TECHNICAL REVIEW COMMITTEE - AGENDA

**Re: Summary of Actions taken to address TRC – P10-49 Notes
Dr. Sandeep Sobti, Tax Map 15, Lot 77, 84 Central Avenue**

TECHNICAL REVIEW COMMITTEE – P10-49 NOTES

Application Type: Site Plan Review
Applicant(s): Dr. Sandeep Sobti
Owner: Memcare, LLC
Location: 84 Central Avenue (Assessor's Map 15 Lot 77)
Date: December 9, 2010

NOVEMBER 2010
 REVISION DATE
 12/21/10
 SHEET S-1

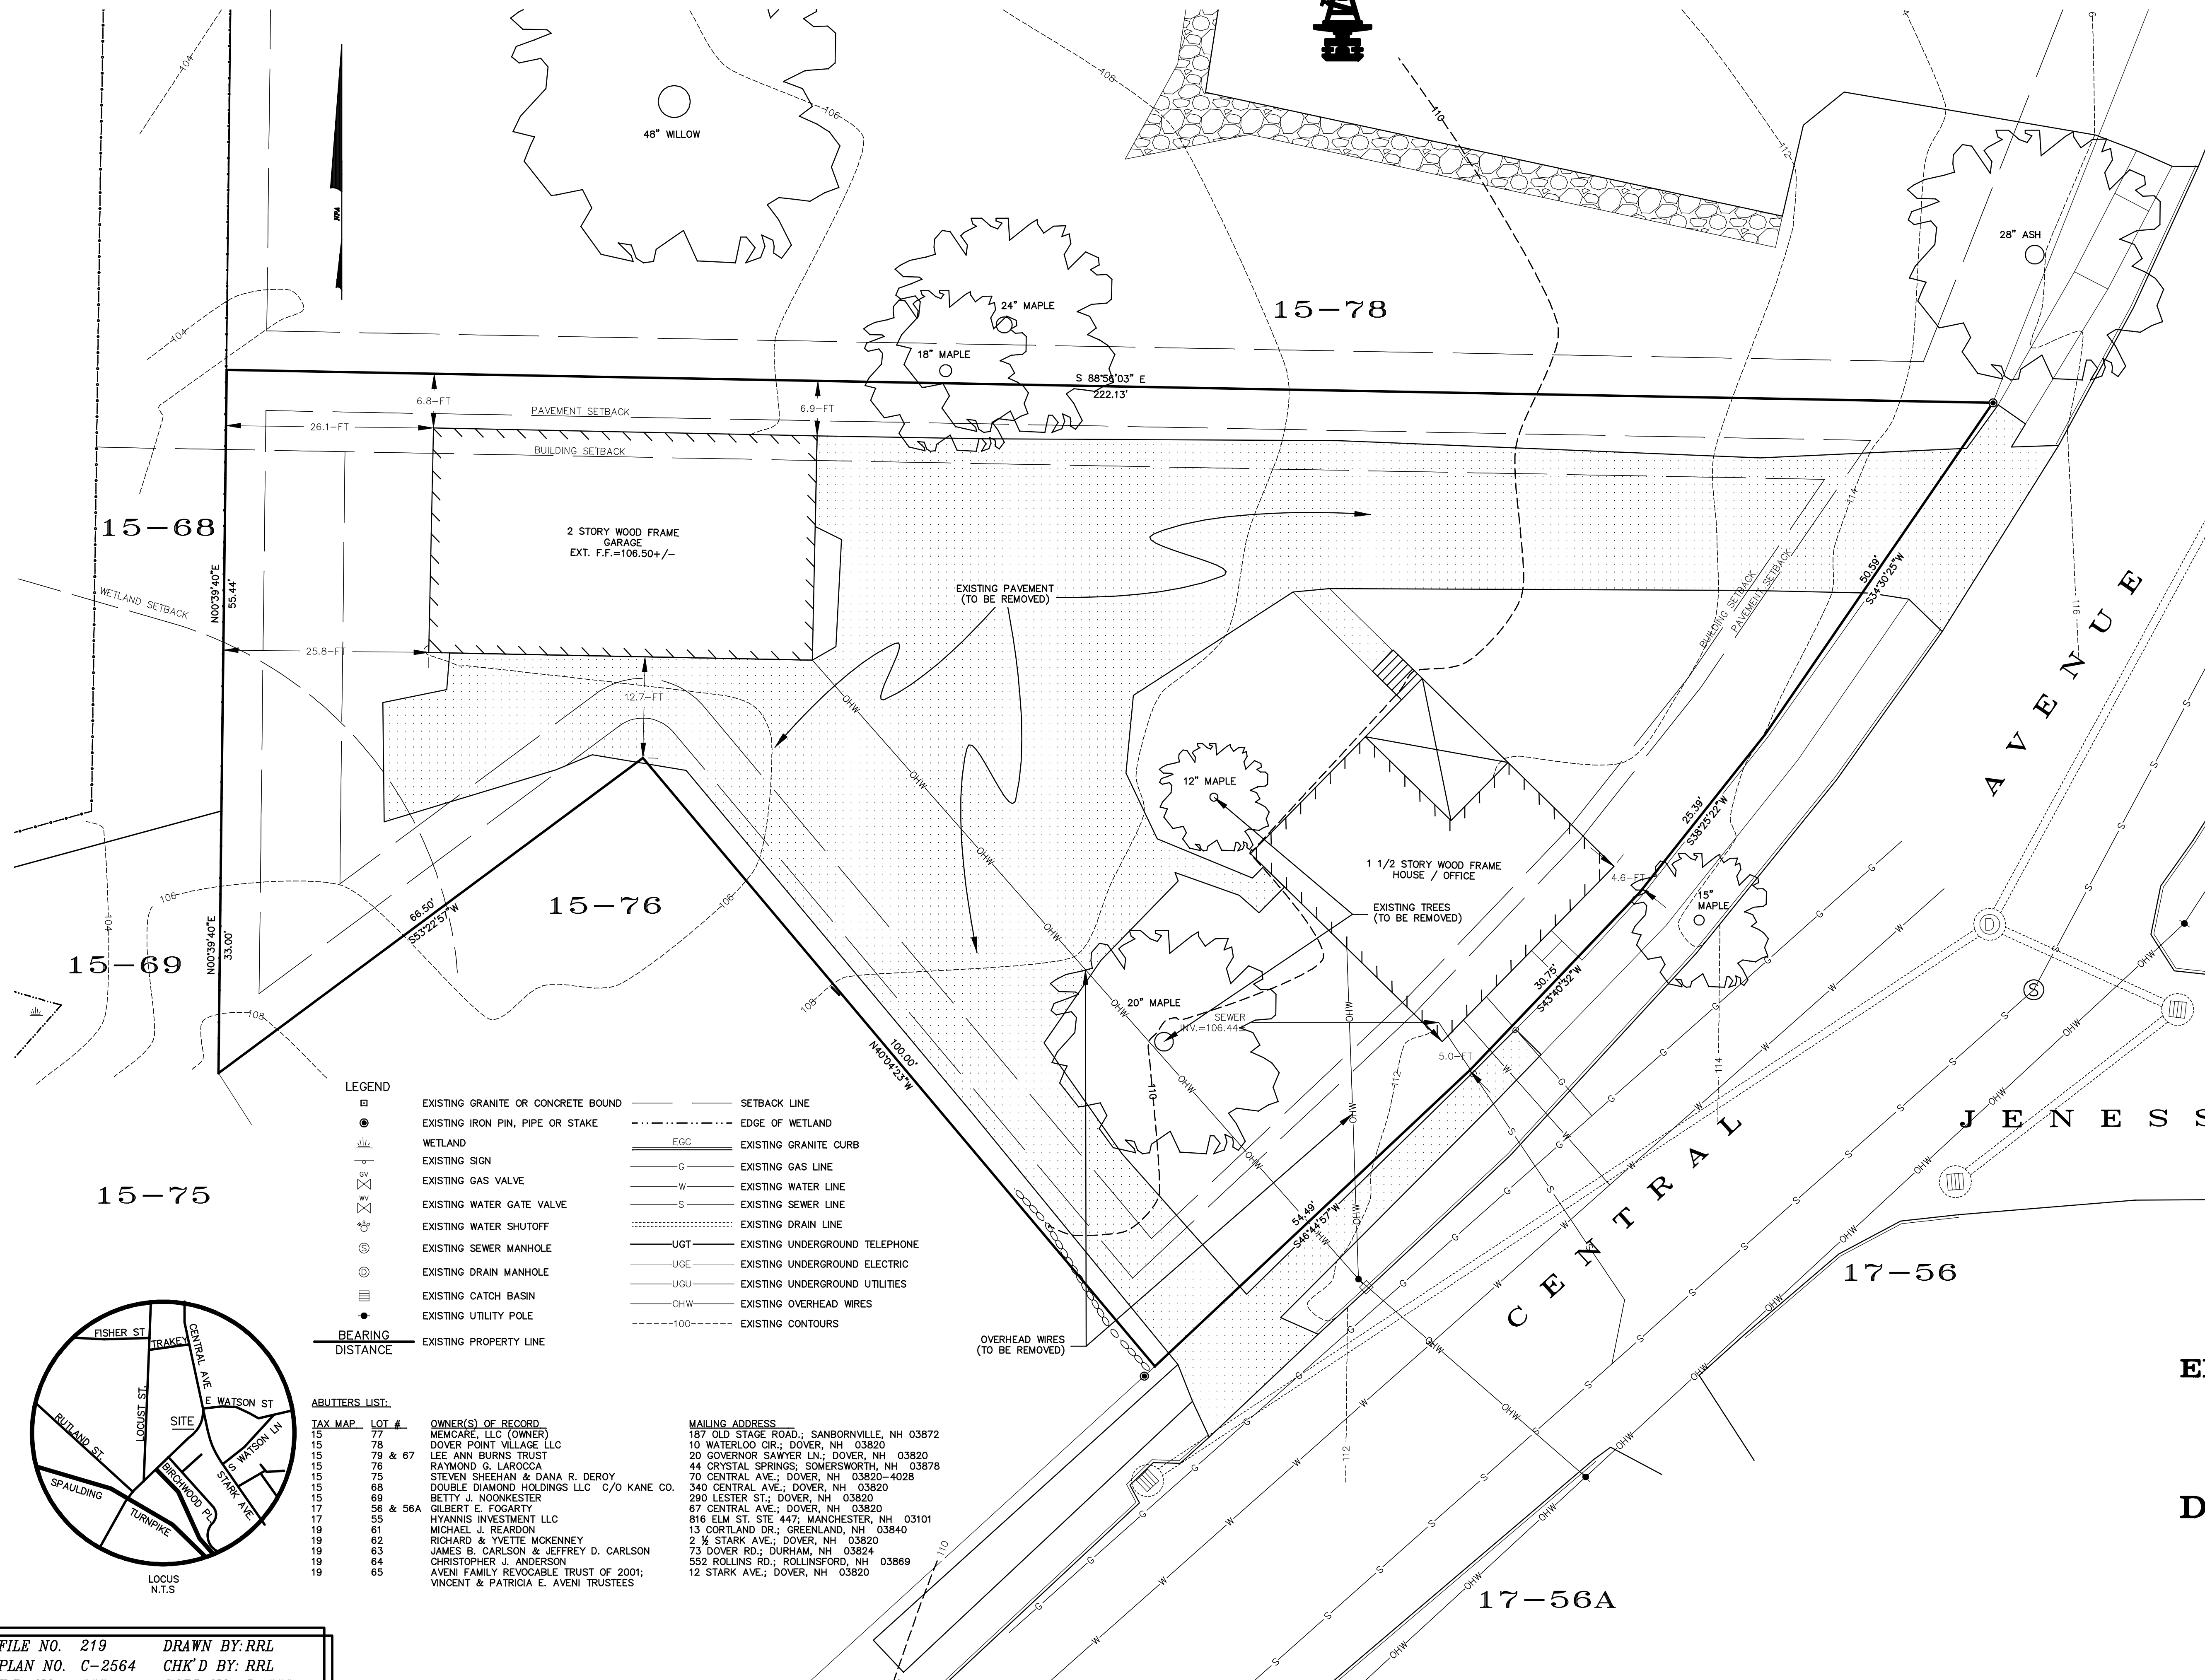
- Question on which building would be "multi-family residential" as per note 22 on sheet C-1. Question was clarified by applicant.
- Any detail regarding a sign at the street? Question was clarified by applicant.
- Replacement sidewalk noted to be "bituminous". Concrete sidewalk connects from the north, would be nice to have concrete sidewalk continue along frontage of property.
- All site lighting is noted to be building mounted. Note that relocated utility pole includes street lamp. Suggestion to show the street lamp on the existing conditions plan and note that it should be retained on the relocated pole.

SHEET C-1

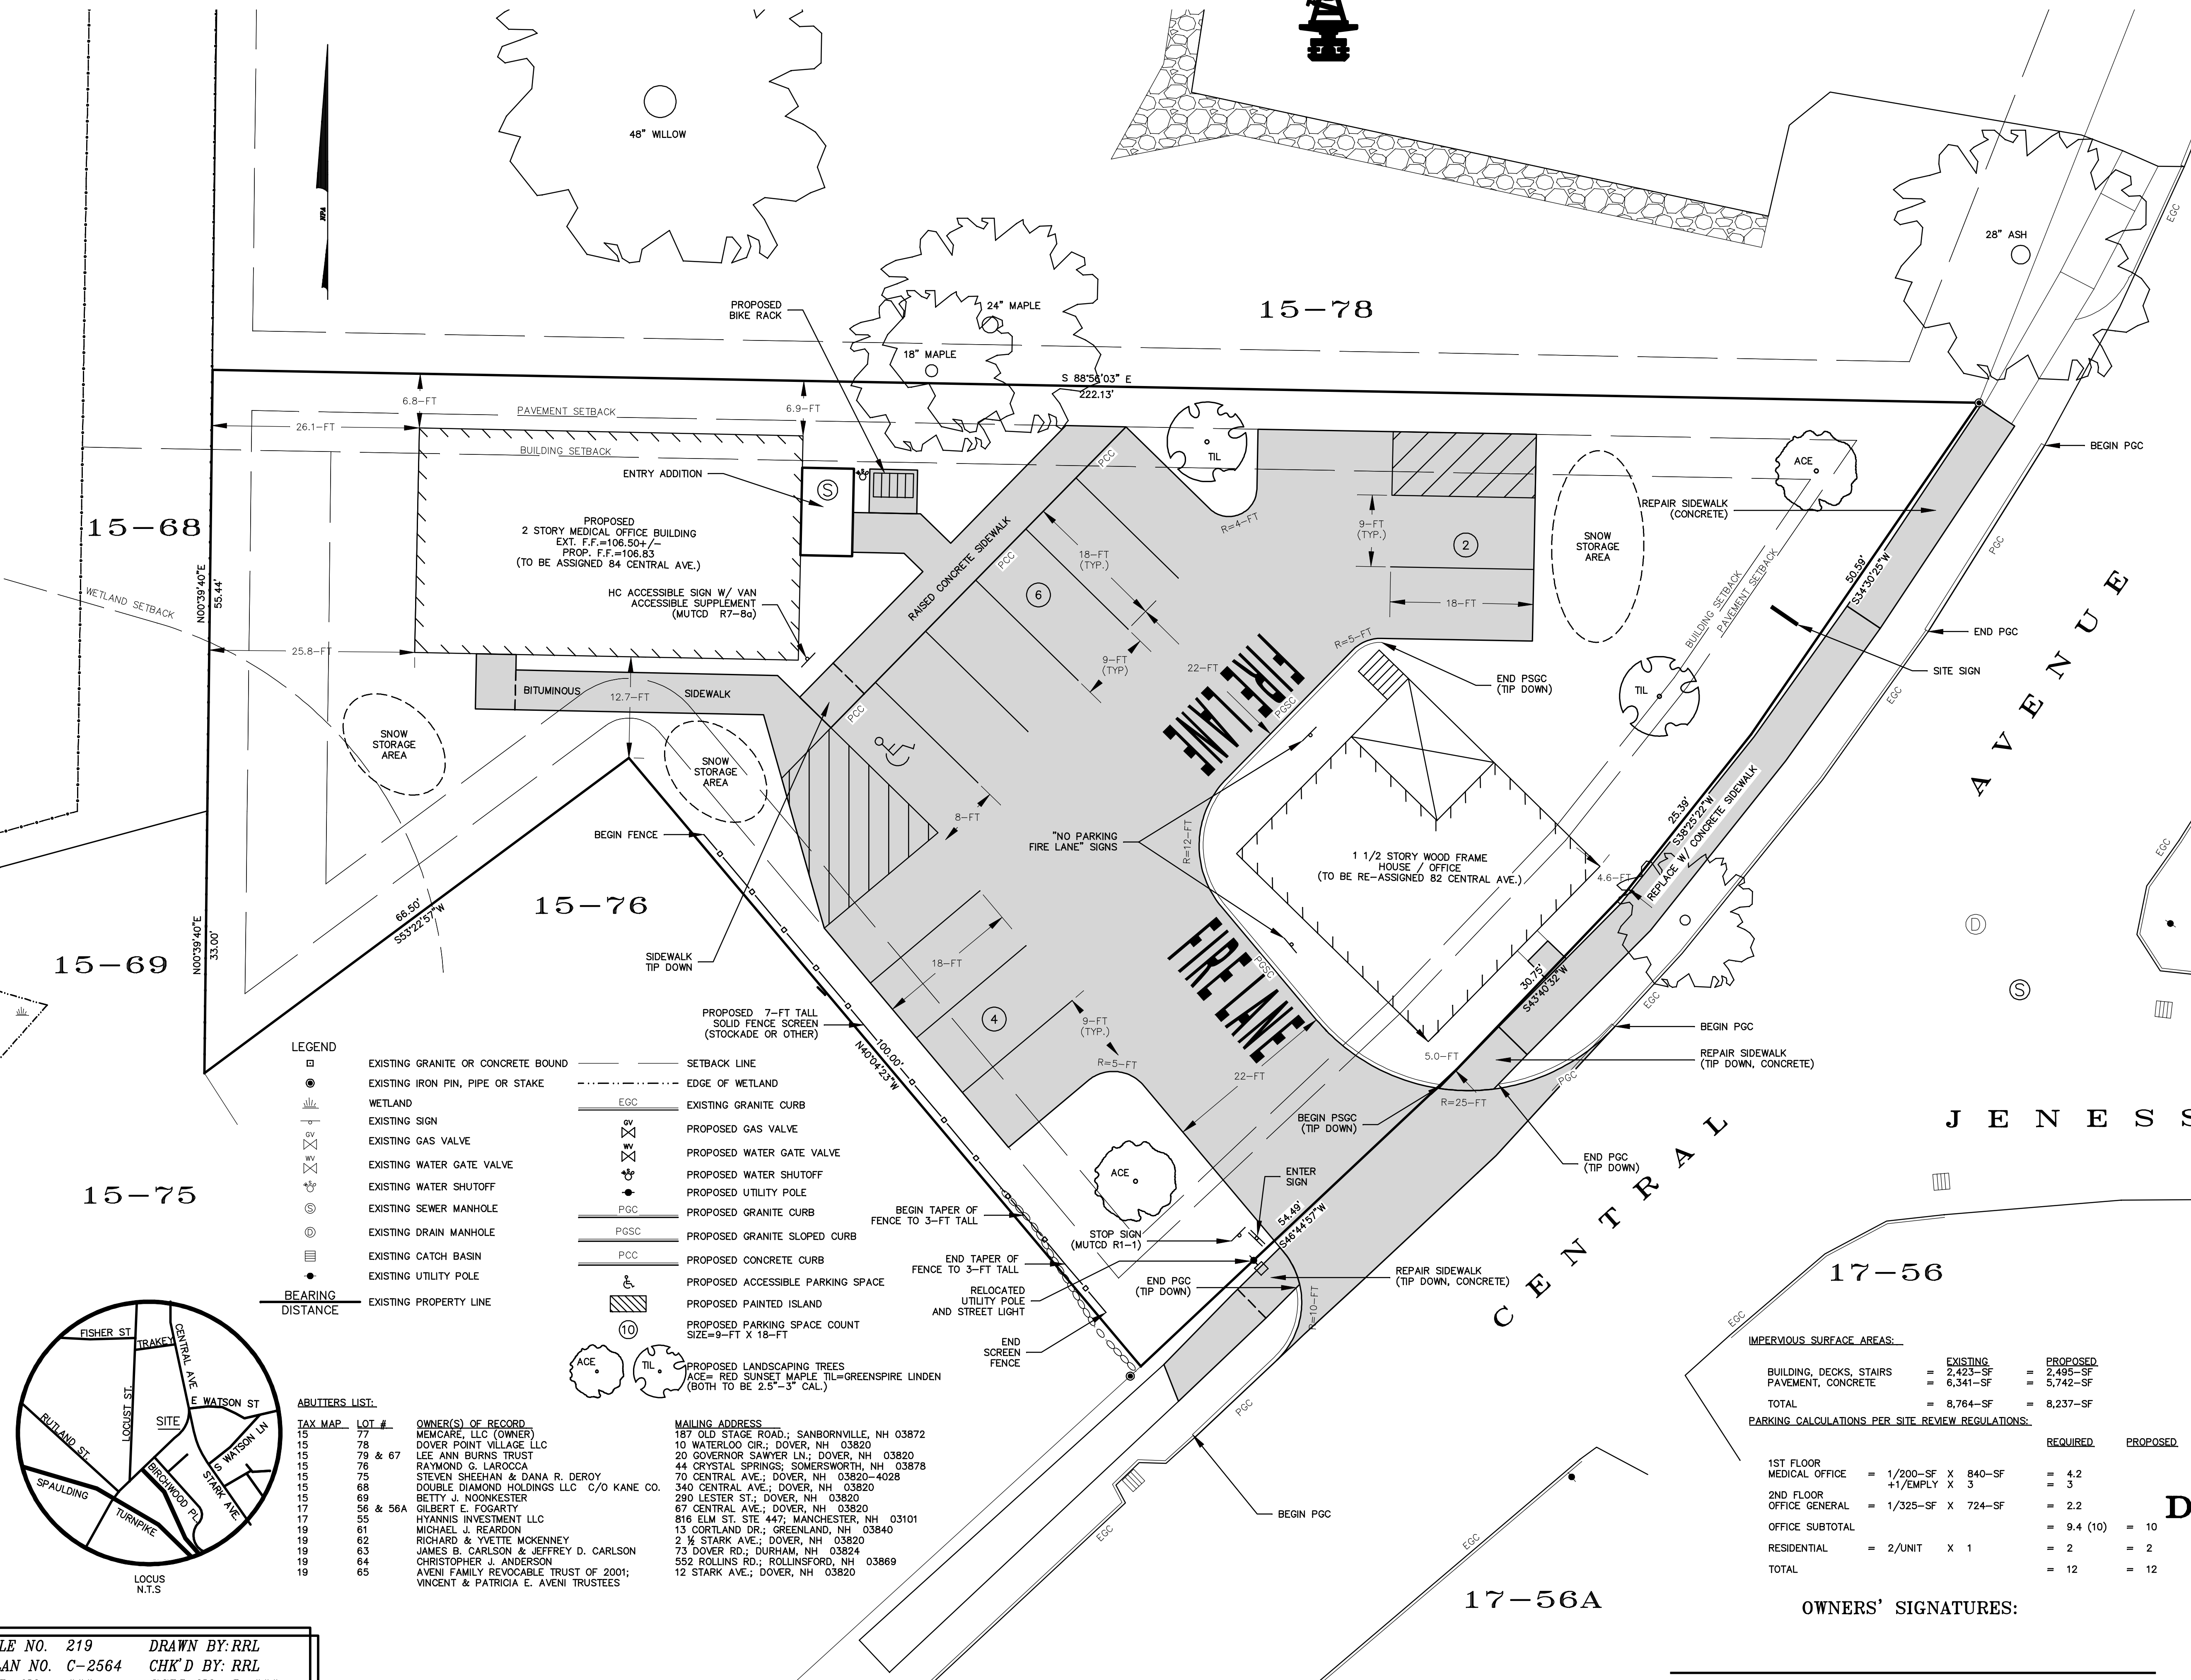
- ***On sheet C-1 how does a pedestrian flow from vehicles to the door.***
This question pertained to the curb stops previously employed. Curb stops have been removed from the design and a standard raised concrete sidewalk has been added to the plan. Pedestrians would access the building from the sidewalk after leaving their car. An accessible ramp is provided adjacent to the Accessible parking space on the southwest end of the sidewalk in front of the office building.

- ***On Sheet C-1 show 7' of fencing required along the parking lot side of lot 15-76, and design it to taper down as it gets closer to the street.***
A 7-ft tall solid screening fence (such as stockade) has been added to sheet C-1. Taper points are also called out.

- ***Explain parking calculation.***
A more clearly calculated parking calculation has been provided on sheet C-1 and an explanation of this calculation was emailed to the Planning Department on December 13, 2010 (see attached).
- ***On sheet C-1 correct note 22.***
Note #22 referred to a periodontal office, which as you may recall was a previous use proposed for the property. The note has been corrected to reflect the Sobti's proposal before the City.
- ***Bike rack***
A Bike rack has been added to the plan and its location near the office entry is called out on sheet C-1. A detail for a typical bike rack is provided on sheet C-3.
- ***Show snow removal areas.***
Snow removal areas have been added to sheet C-1.

- ***Consider revising the parking lot to include dropping the elevation and including asphalt curbing.***
This comment pertains to the sidewalk in front of the proposed office. The parking lot grading has been revised in order to provide a concrete sidewalk and integral concrete curb in front of the parking stalls per the recommendation.

- ***Show the street light on the relocated utility pole.***
A note with leader and a symbol have been added to sheets C-1 and C-2 to denote the street light as relocated too.

- ***Need a fire lane, striped and signed on the northeast section of the parking lot beginning at the driveway entrance following along the proposed sloped granite curb at the end (at the tip down).***
"FIRE LANE" striping and "FIRE LANE NO PARKING" signs have been added to the plans and can be seen on sheet C-1.

Tom Clark contacted Norway Plains and informed us that the Office building can be 84 Central Avenue and the House can be 82 Central Avenue as was the preference of the Sobti's. Notes to this effect have been added to each building on sheet C-1.

There was some discussion of trees, sign location etc. at TRC. A Site sign has been added to the plans on Sheet C-1 between the two proposed trees to the north of the house. An "ENTER" sign has been added to the south of the driveway. Four trees are proposed on site three along Central Avenue and one in an island within the site. The areas in front of the office are intended to be planting beds/landscaped areas. The site already has some established lawn areas between the house and existing northern driveway (to be removed). The Sobti's will likely landscape the property to enhance their new office but due to the size of the site (very small) do not want to be locked into much more than what is proposed.
